-ADVISEMENT-
PARKING
(SUMMARY REPORT)

March 2018

Subcommittee: S. Yerardi

ADVISEMENT – PARKING

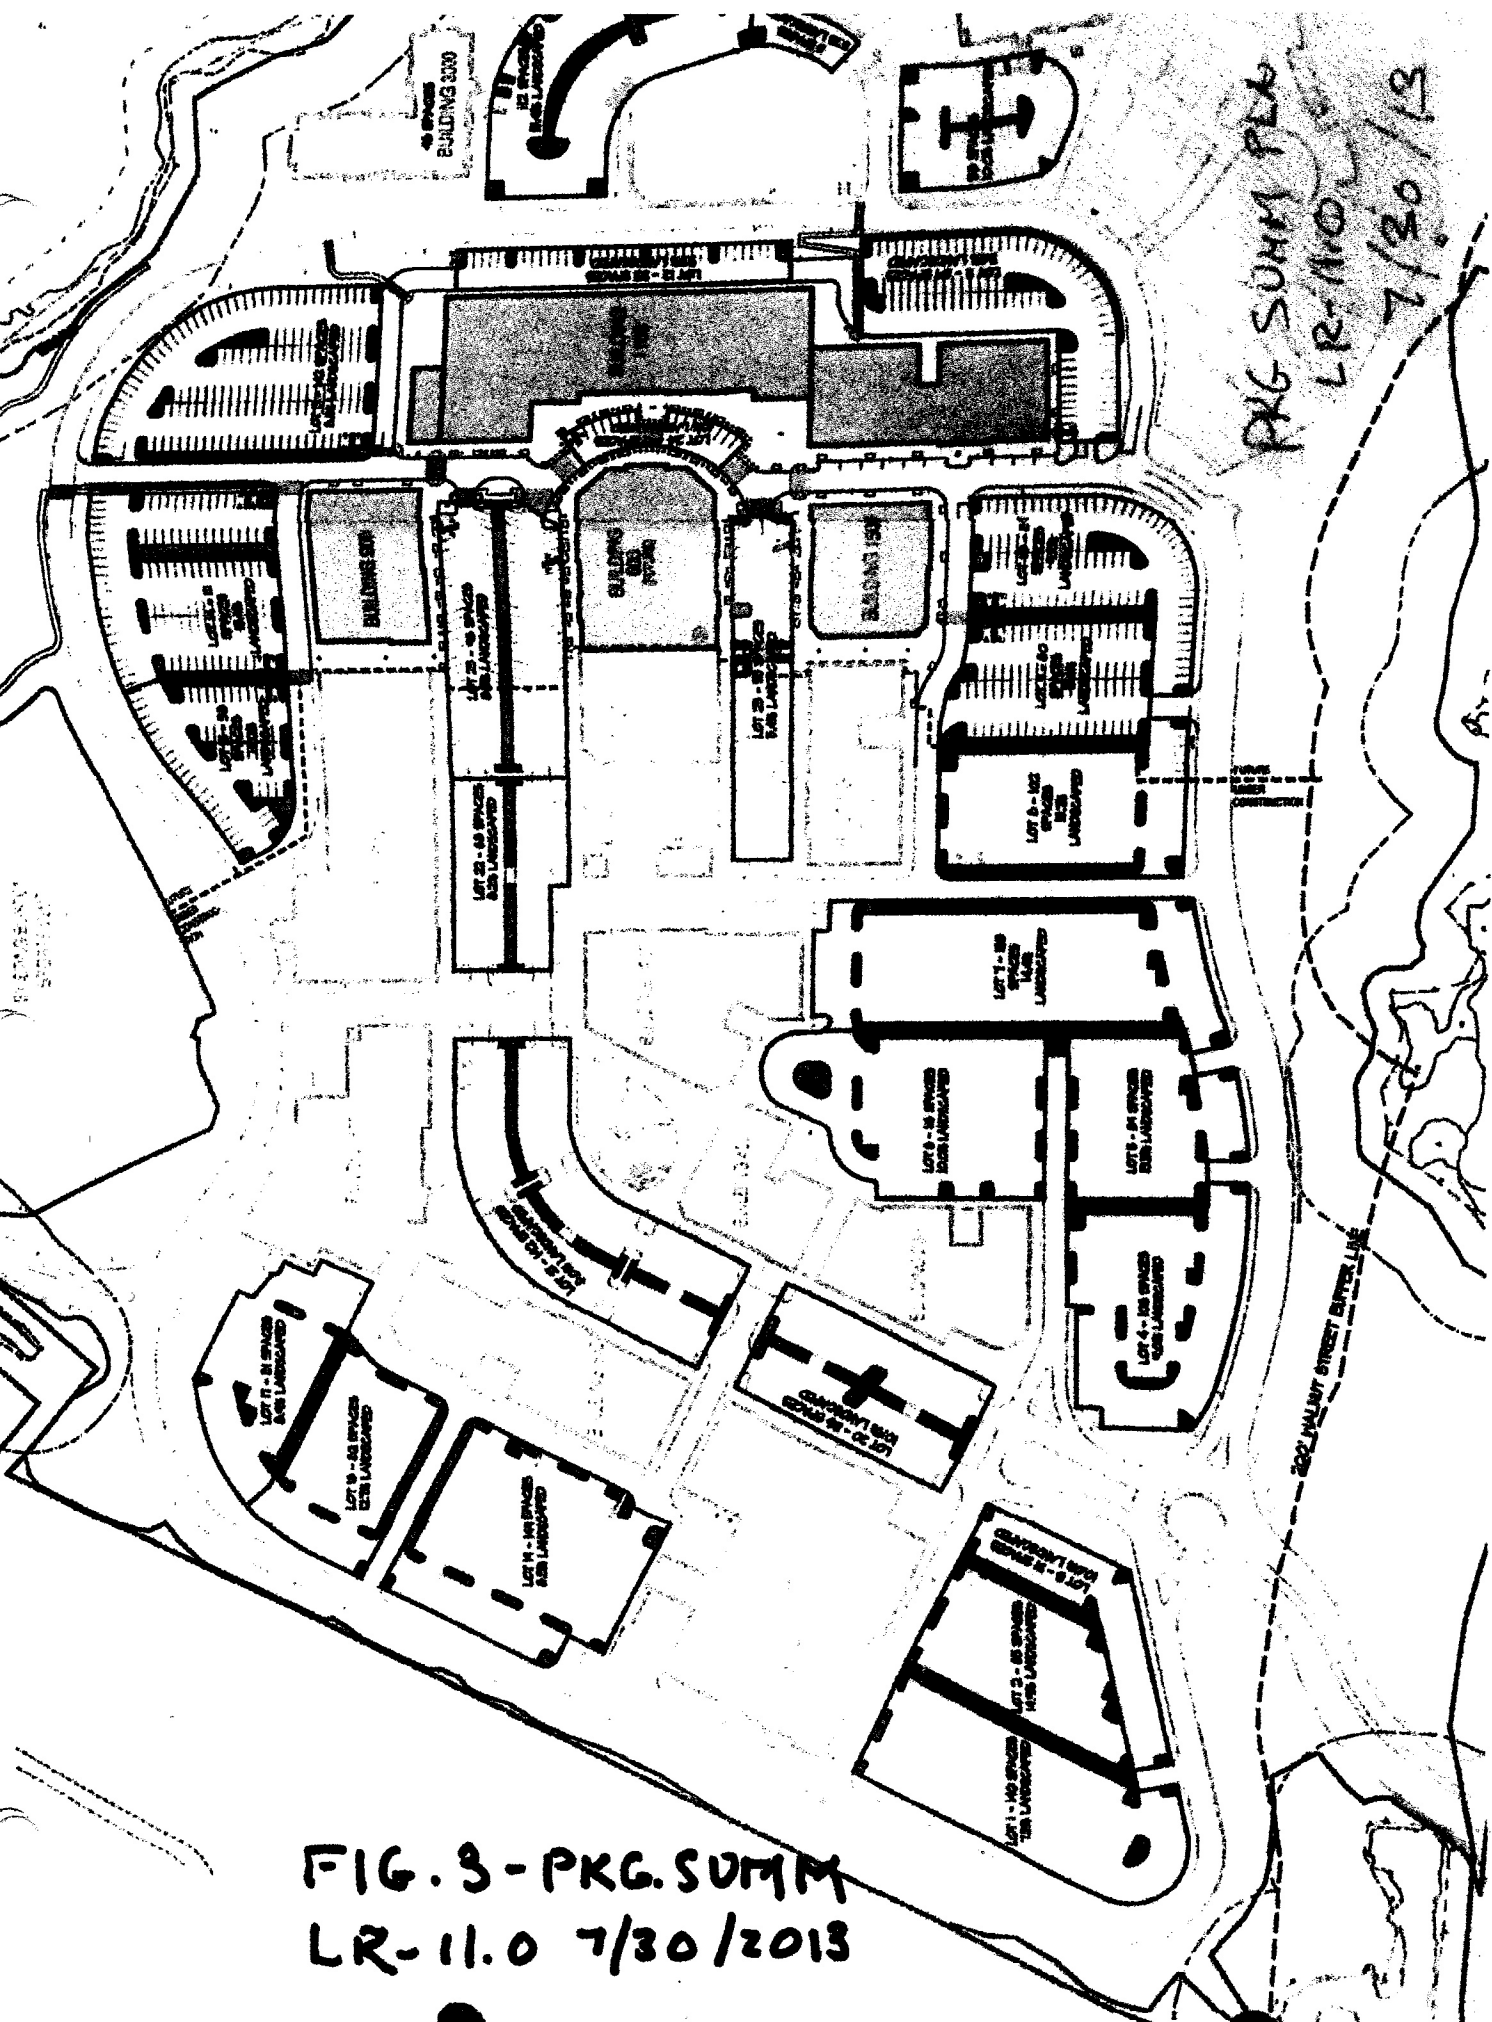
9. It is recommended that National Development evaluate alternate locations for a proposed parking structure. As presently proposed, the parking structure would be constructed adjacent to California Pizza Kitchen and located directly across from the residential area formed by Colonial Village and the MarketStreet Apartments. Residents there would experience the effects of increased traffic, noise, lights, etc. and several homes in this area could be less than 125 feet from the parking structure. A walk down was performed and two alternate locations, away from residents, were identified. These locations are the existing parking lot areas generally behind Whalburgers and Whole Foods. These alternate locations, being near Audubon Road, should be more accessible to/from Exit 42 and should promote its use by the public. Having the parking structure location adjacent to the proposed theatre as has been done at Legacy Place would appear to be a benefit since moviegoers want to park close to the theatre

Section 9.5.7.13 of the bylaws states "Structured parking in the Traditional Neighborhood Village Sub-District shall not exceed forty-five (45) feet in height and shall be approved as to capacity and location by the Approving Authority"
